NORTHERN VIRGINIA STREAM RESTORATION BANK
THE GLADE - REACH 4A

Preliminary Plan

Sheet #
2 of 3

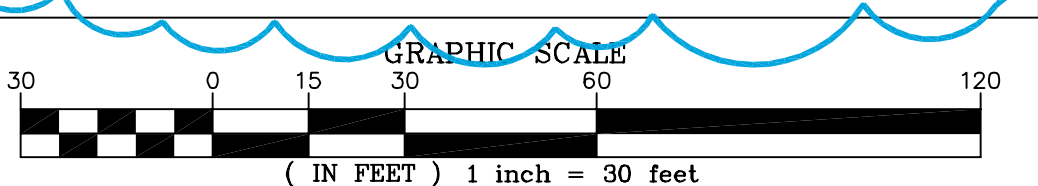
1
REVISED ALL LIMITS OF CLEARING AND TEMPORARY ACCESS PATH TO STANDARDIZE WIDTH, PROVIDE STORAGE, AND INCLUDE STREAM.

10
DO NOT REMOVE TREES ON RIGHT BANK (20449-20452). FILL IN AND AROUND ROOTS TO STABILIZE.

9
REACH 4A 11+10 TO 28+40. WIDTH = 16.5', DEPTH = 1.8', PROPOSED LENGTH = 1,730', R_c MIN = 41'

9
REACH 4A 28+40 TO 33+70. WIDTH = 18.0', DEPTH = 1.9', PROPOSED LENGTH = 530', R_c MIN = 45'

PROPOSED BRIDGE RELOCATION OFF OF SANITARY EASEMENT AND D/S TO AVOID UTILITIES. U/S ALTERNATIVE IMPACTS MORE TREES TO RECONNECT TRAIL. WSSI ID #16 RESTON PLAC. #62

TREES 20416 AND 20425 ARE 15.4' APART. PROPOSED REALIGNMENT PROTECTS TREES.

EXISTING MEANDER VERY TIGHT. PROPOSED MEANDER SIZE MINIMIZES TREE IMPACTS.

5
TREE 20285 IS LEANING ONTO ADJACENT TREE.

10
DO NOT REMOVE TREES ON RIGHT BANK (21165) FILL IN AND AROUND ROOTS TO STABILIZE.

5
WALL WITH FENCE (BRIDGE RAILING) PROPOSED NEAR TRAIL TO MINIMIZE TREE IMPACT ON INNER BANK.

14
OFFSET EACH ROCK TIER 6' TOWARD BANK.

5
TREE 22035 IS LEANING. (REQUESTED BY HOMEOWNER)
